**TO:** Tasha Bolivar, Galloway and Company  
**FROM:** Amber Wood Hicken, Planner I  
**DATE:** 5/25/23  
**SUBJECT:** Parker and Pine F1 L1 – In-n-Out Burger, Site Plan  
Review Comments 02

# CIRCLE K SITE DEVELOPMENT PLAN

**SITE DEVELOPMENT PLAN**

COVER SHEET

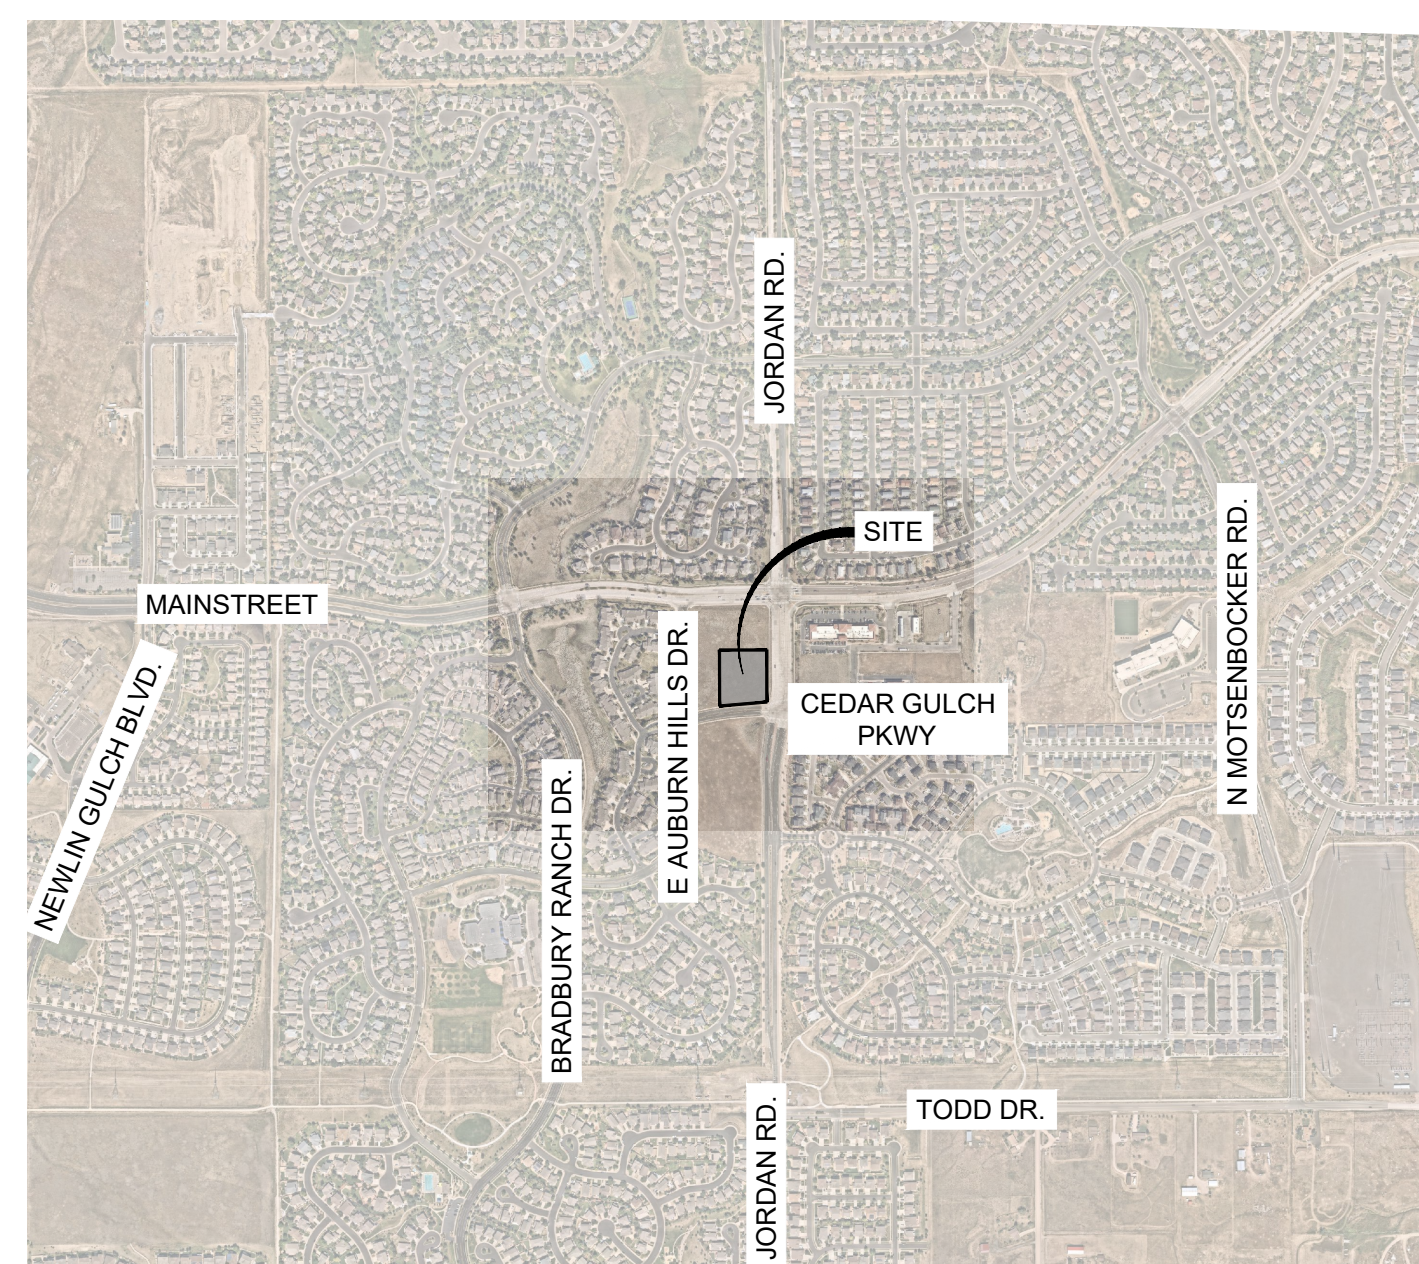
Please change title to  
legal description -  
Auburn Hills Centre L4

SHEET TITLE:  
**SITE PLAN**

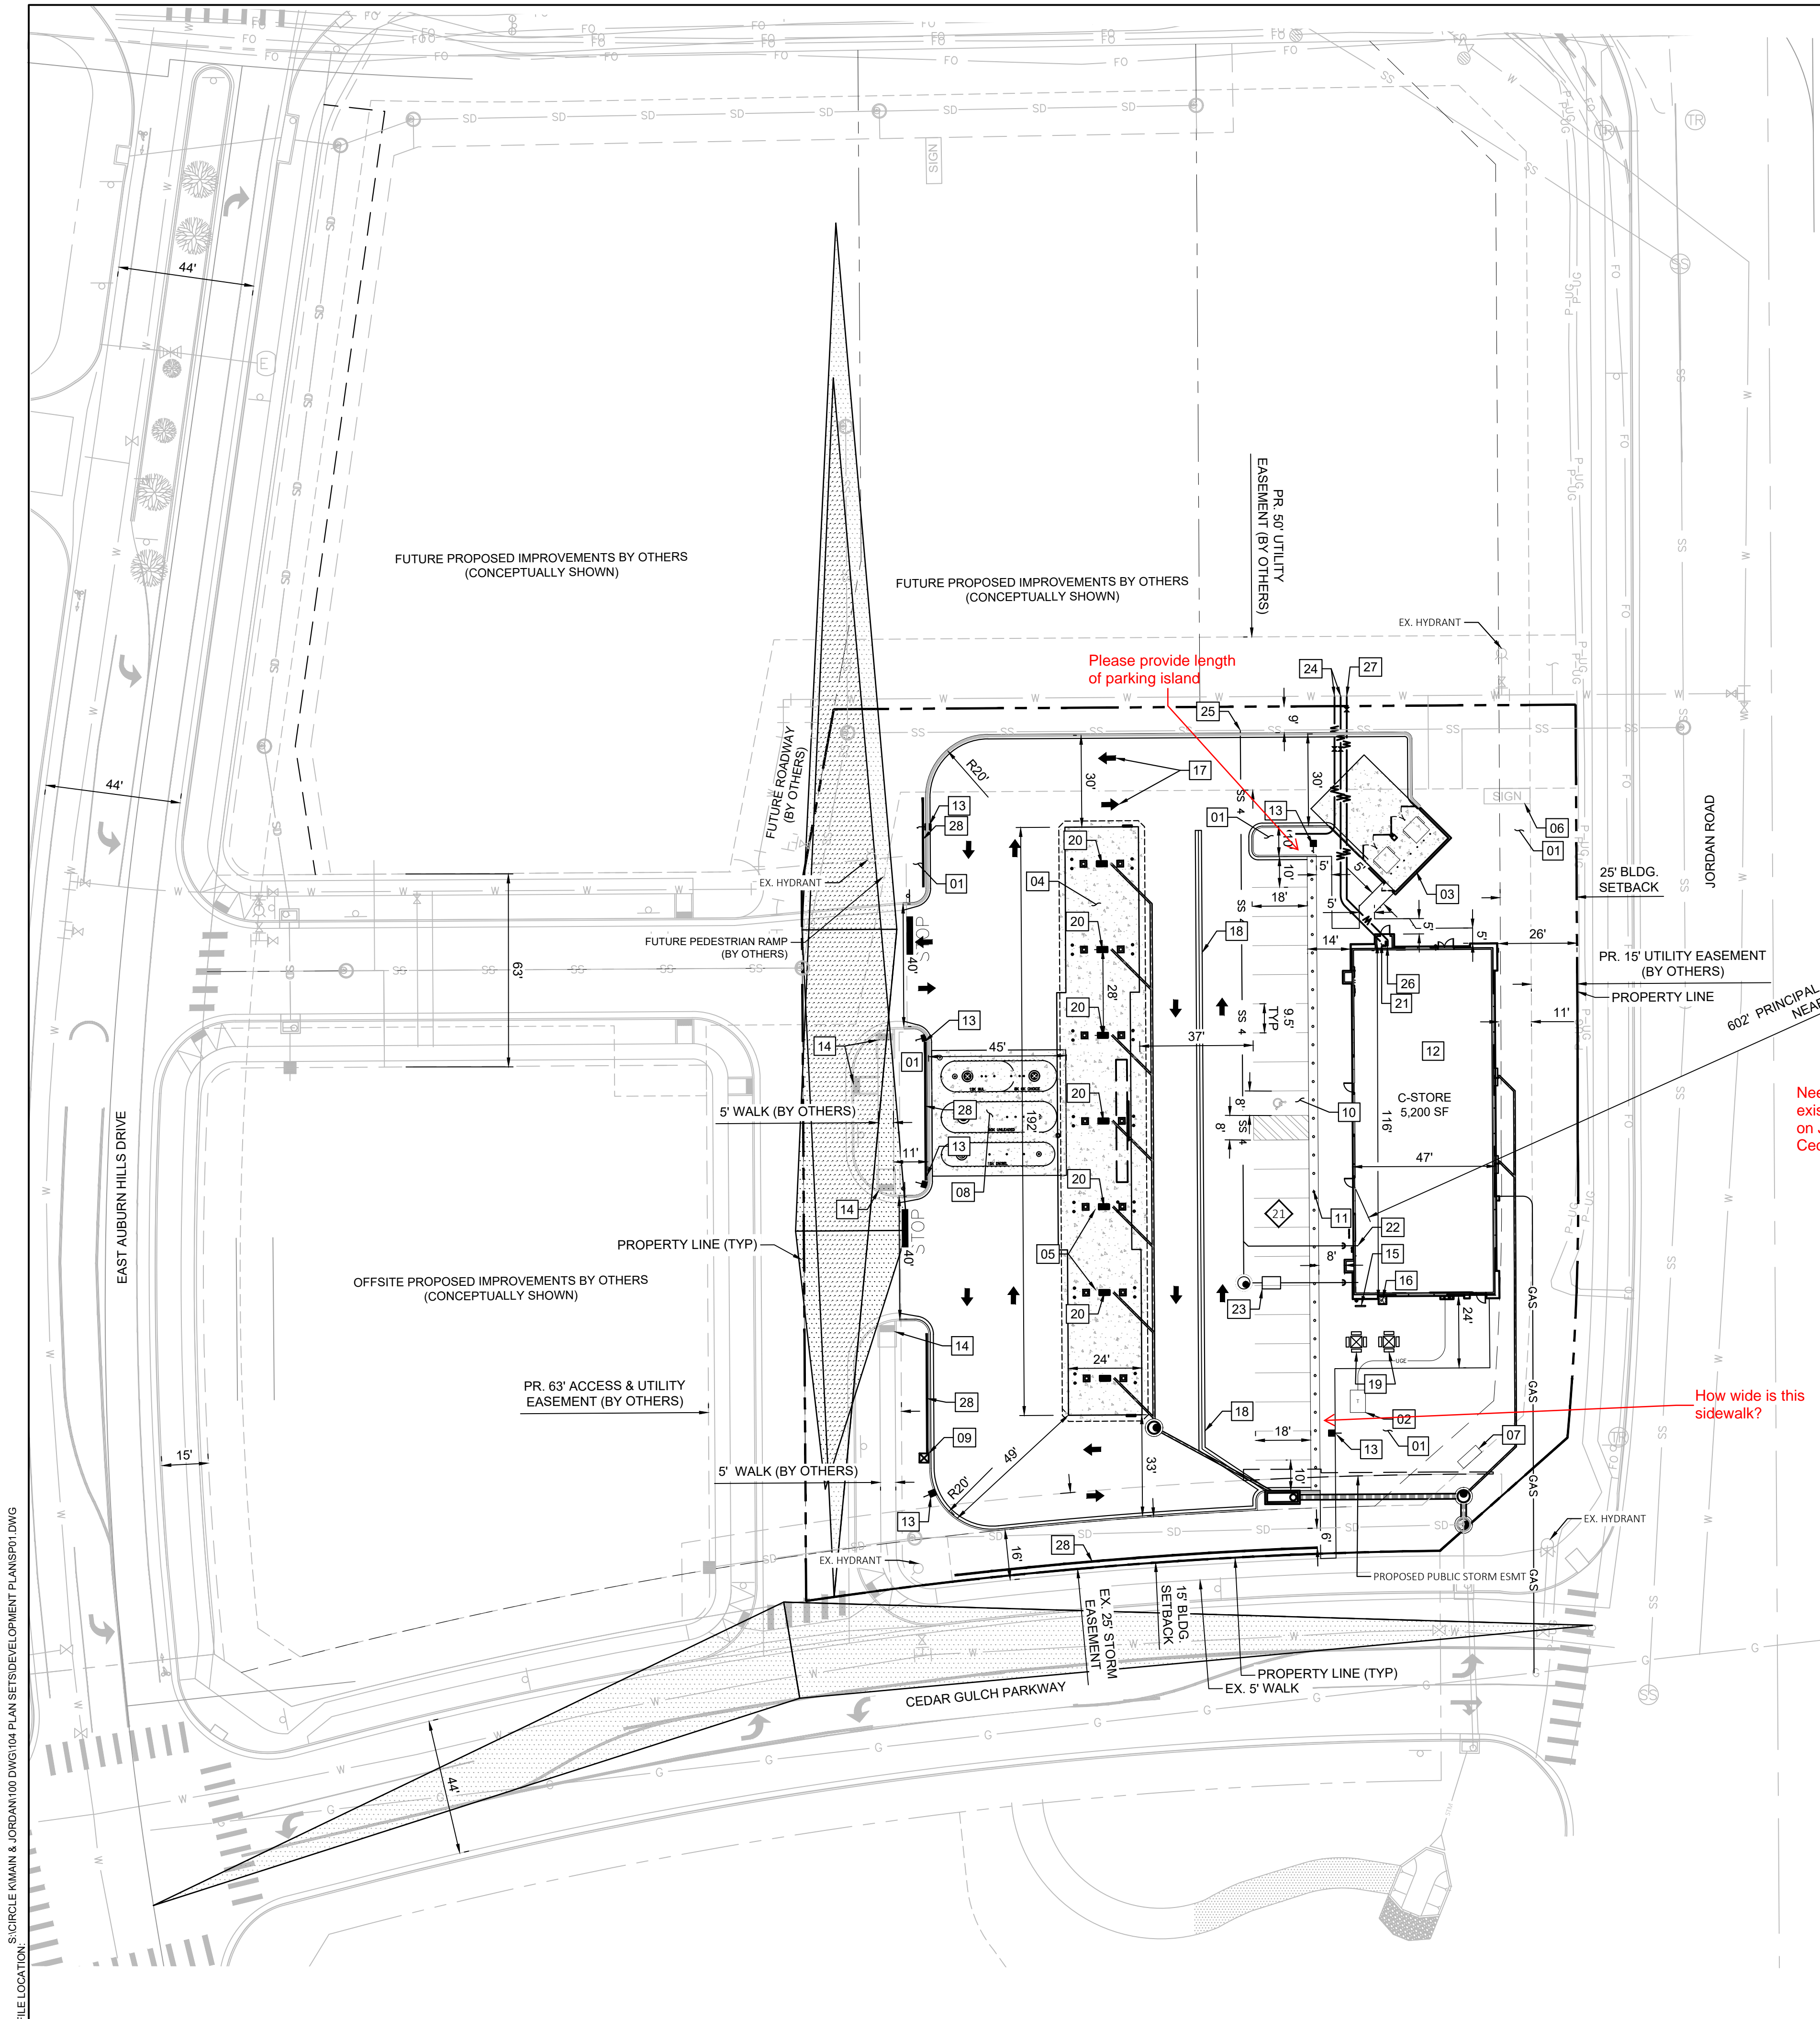
Add a note stating this sign will not be approved as part of this site plan process

Please provide detail sheet - colors, materials

Need sidewalk connection to existing detached sidewalks on Jordan Rd, Main street, Cedar Gulch

How wide is this sidewalk?

**LANDSCAPE PLAN**

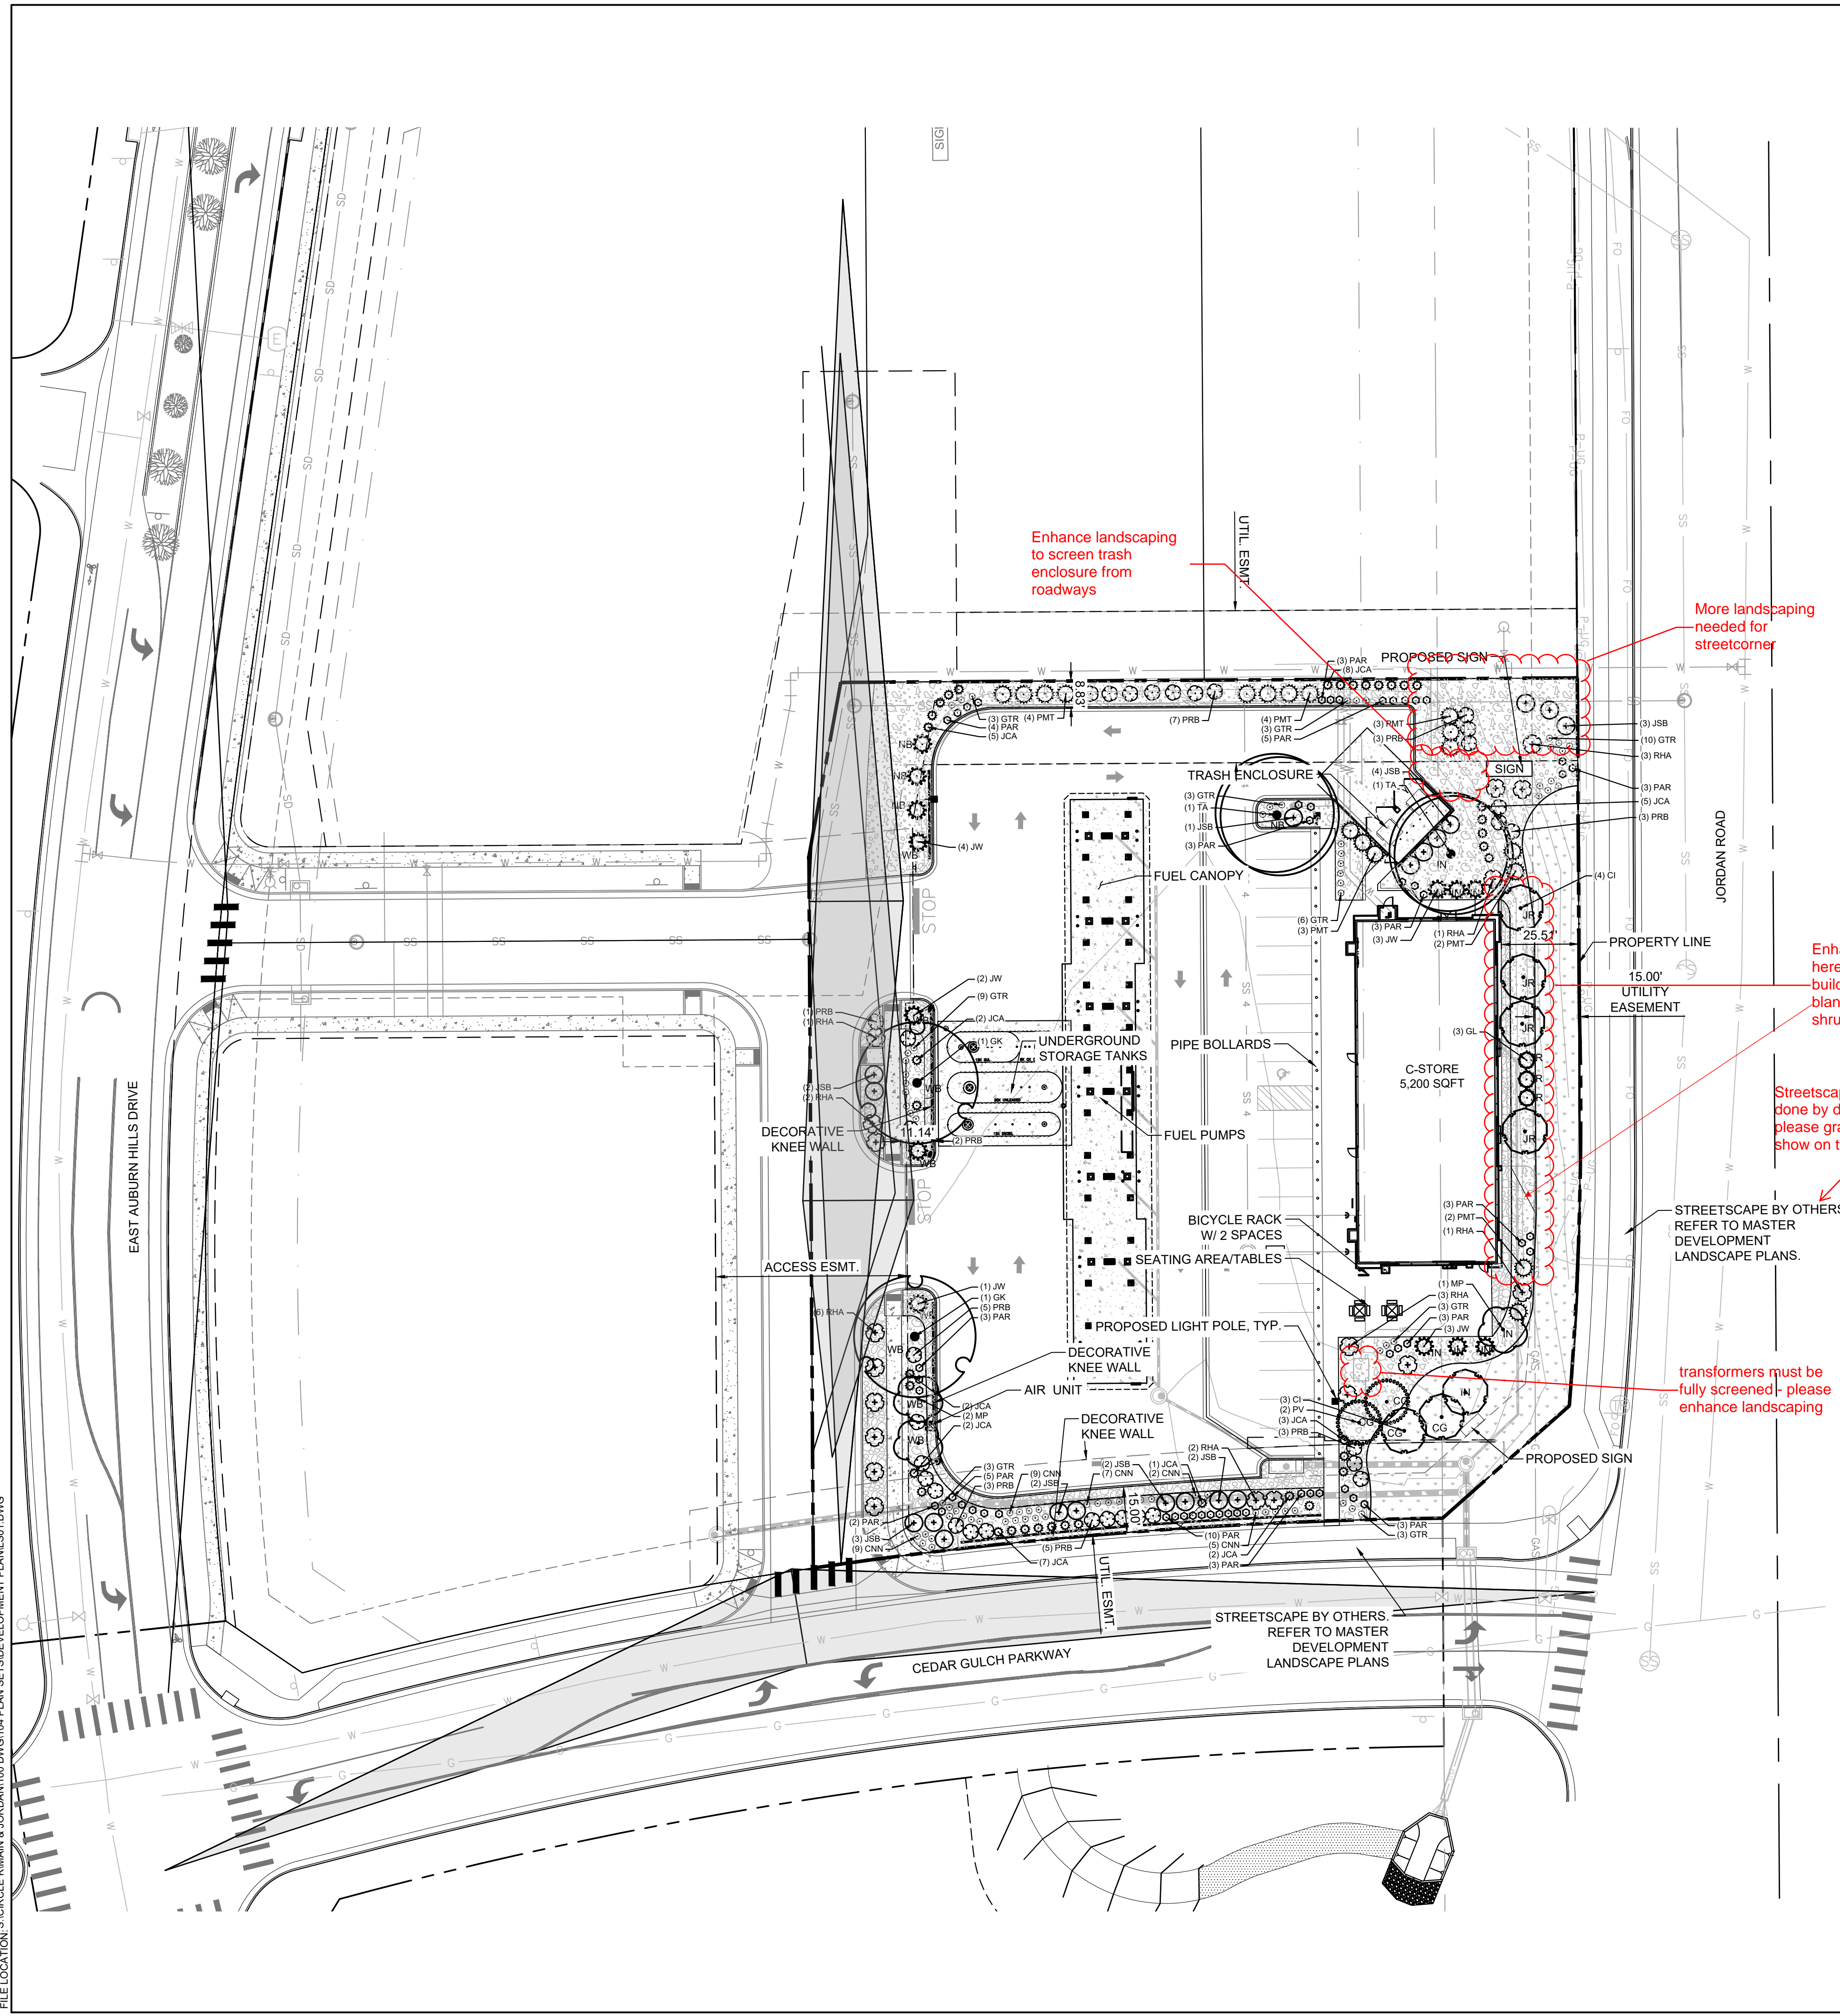
Add calculations for streetscape - need to be included as part of this site plan

Enhance landscaping to screen trash enclosure from roadways

More landscaping needed for streetscoper

Streetscape will be done by developer, but please gray back and show on this plan
